Technical Service Bulletin
4/26/21

Title: Unprotected 12v floor mounted stud terminal

TSB - 015

Models: All 2020-2021 Yetti's with interior's built by Nelson Industries

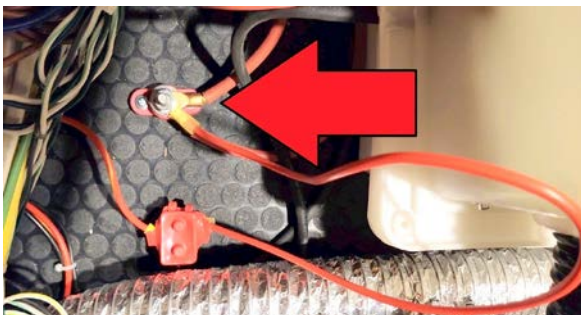
Issue: An unprotected 12v floor mounted stud terminal may allow accidental grounding of this positive circuit. Voyager Industries recommends that customers with units with this condition protect the stud terminal with the free protective cover.

There are many variations of how the electrical systems were installed. This shows the stud terminal in its most common position. If you are uncomfortable performing this installation, please feel free to contact the closest dealer and schedule a service appointment.

In this photo the red arrow points to the positive terminal post for the Yetti's 12-volt system. This connects directly to the positive terminal on the battery on most 2020 – 2021 units with interiors installed by Nelson Industries.

Action: Customers may choose to Install the protective cap onto the stud terminal themselves by requesting a free of charge service kit #51869 ELEC-TERMINAL COVER.
